ADDENDUM NO. 30

PROJECT NO. DGS C-0211-0005 PHASE 005
PROJECT TITLE - PA State Police Academy - Core Bldgs, BESO & Sitework
PROFESSIONAL:
SOM
7 World Trade Center
New York, NY, 10007

Item 1 - **PLEASE NOTE:** This is a re-upload of **Addendum 29**, with attached drawings, specifications and references throughout to **Addendum 29**.

2 BOLLARD
SCALE: 1-1/2" = 1'-0"

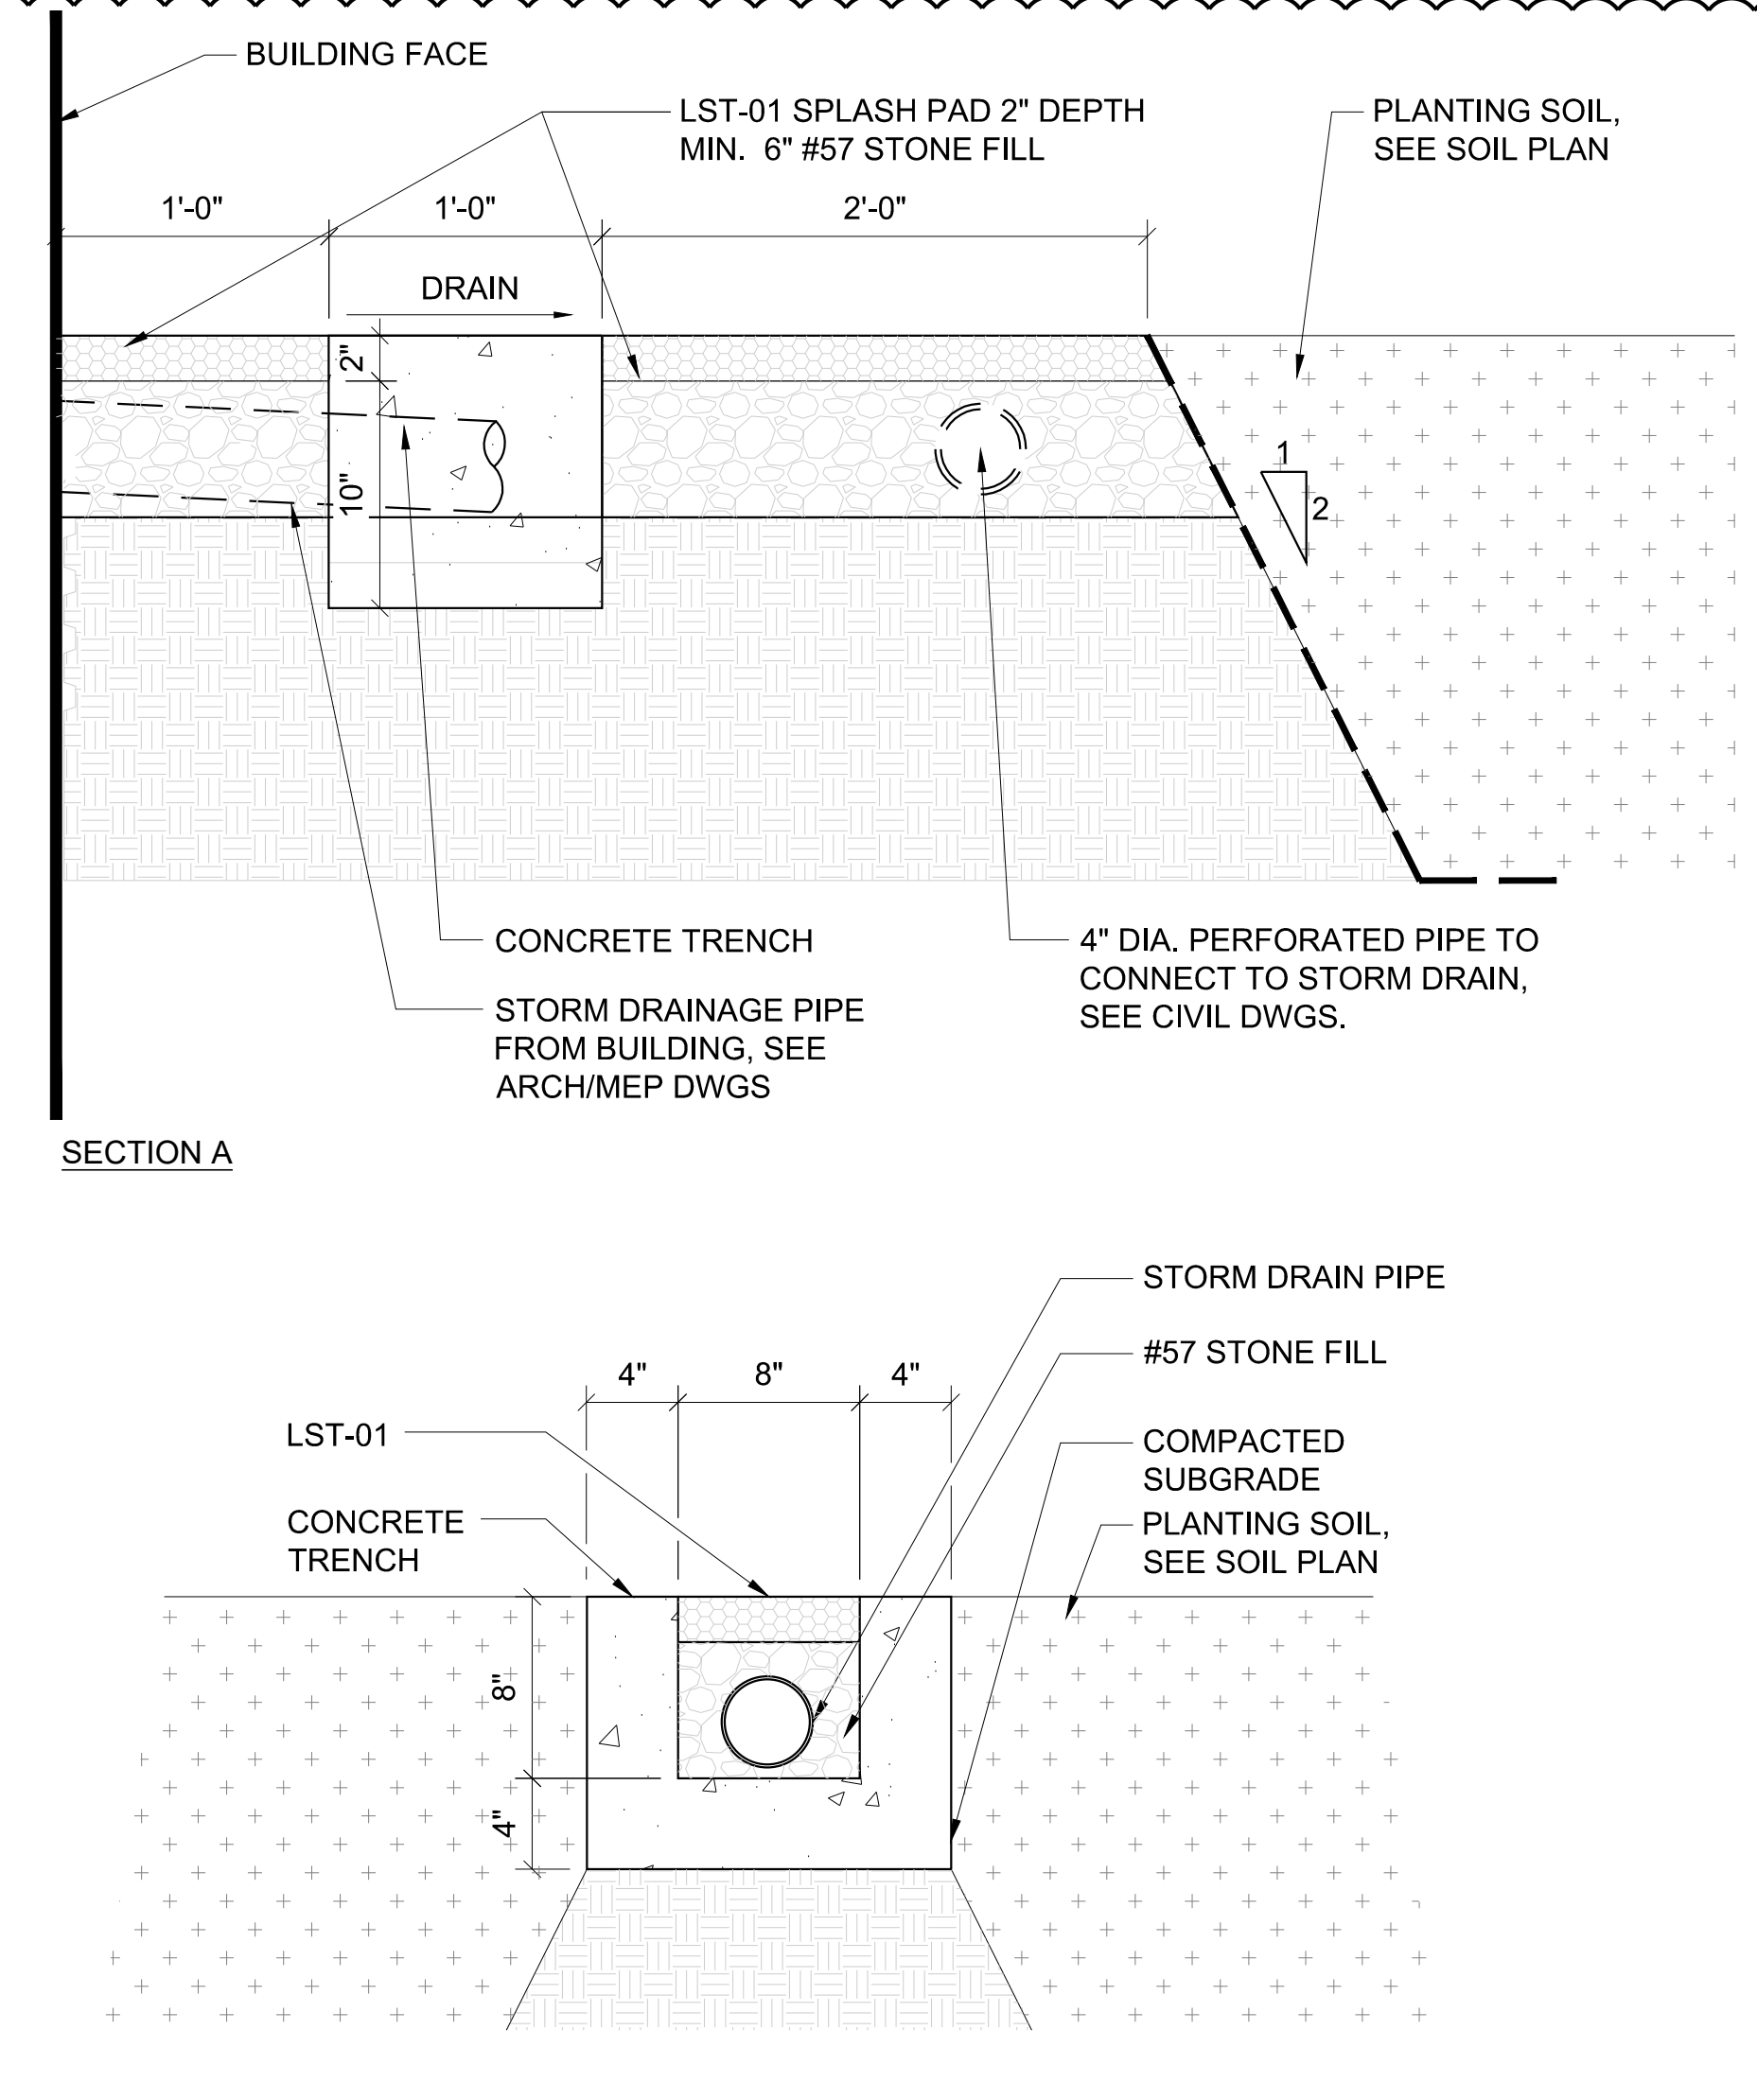
- Question 106: Bollards: STE-C-451 has a bollard detail and STE-L-901 has a different bollard detail. Please confirm which detail goes where.
- Response: Bollards shown in details 2/STE-L-901 and included in Materials Schedule apply only to bollards explicitly called out in the Landscape drawings on Sheets STE-L-104 and STE-L-104_D. All other bollards, including at trash enclosure should follow the Civil detail.

5 SITE WALL
SCALE: 1/2" = 1'-0"

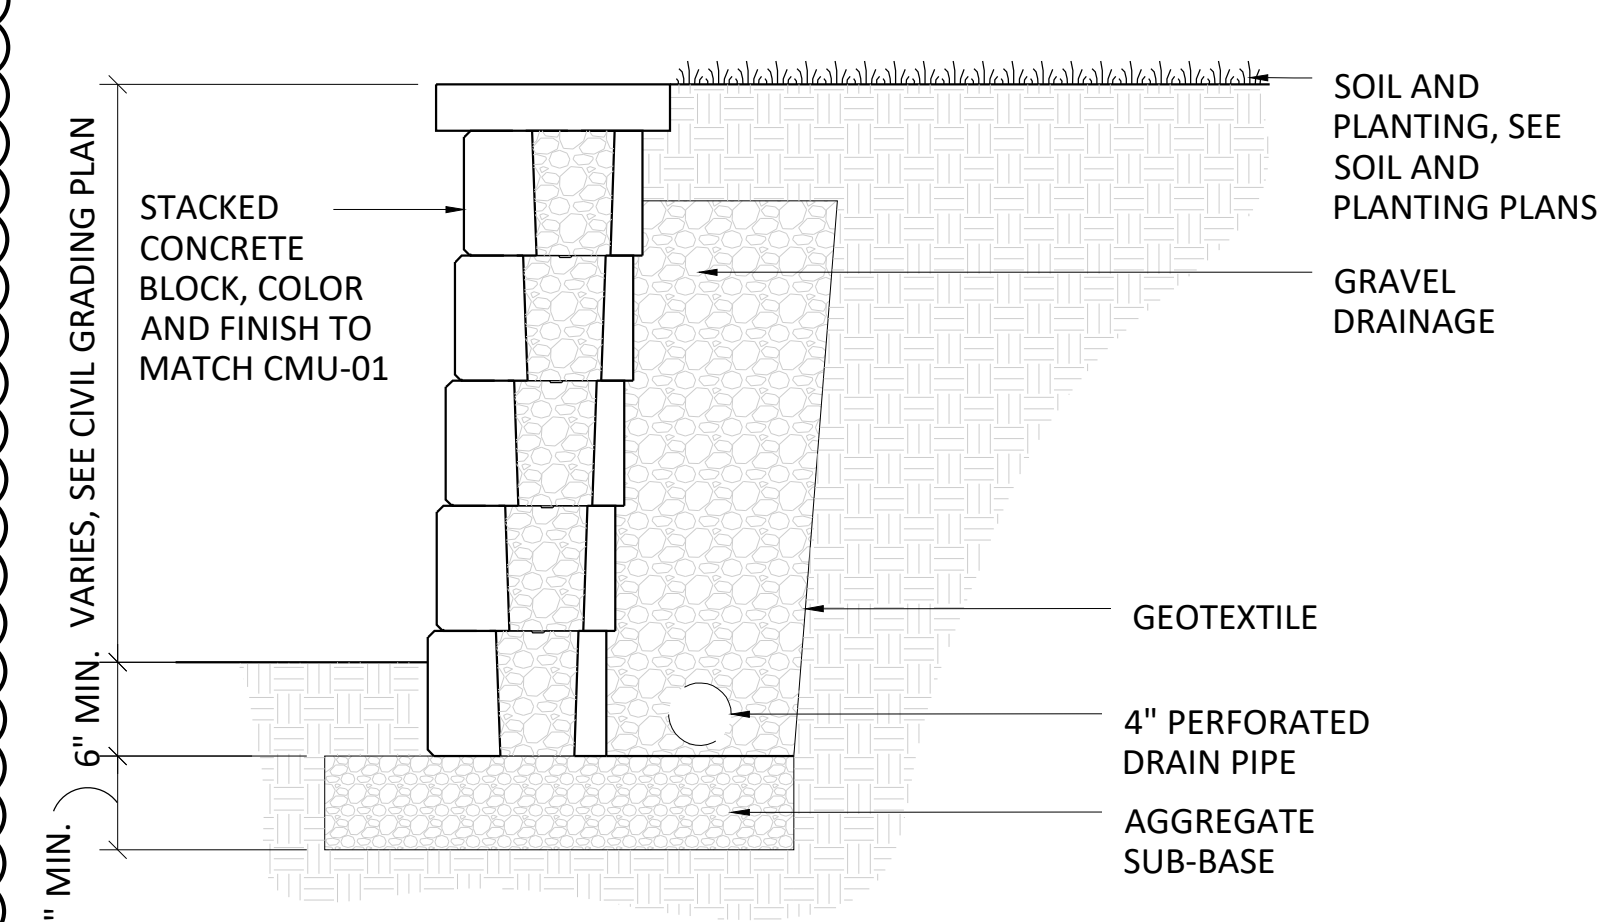
- Question 104: Retaining Walls: STE-C-454 has a detail for retaining wall. 5/STE-L-901 also has detail for site retaining wall. Please confirm which details apply where.

- Response: Detail 5/STE-L-901 only applies to the site wall explicitly called out in the Landscape drawings on Sheet STE-L-104. Refer to Civil details for all other site retaining walls.
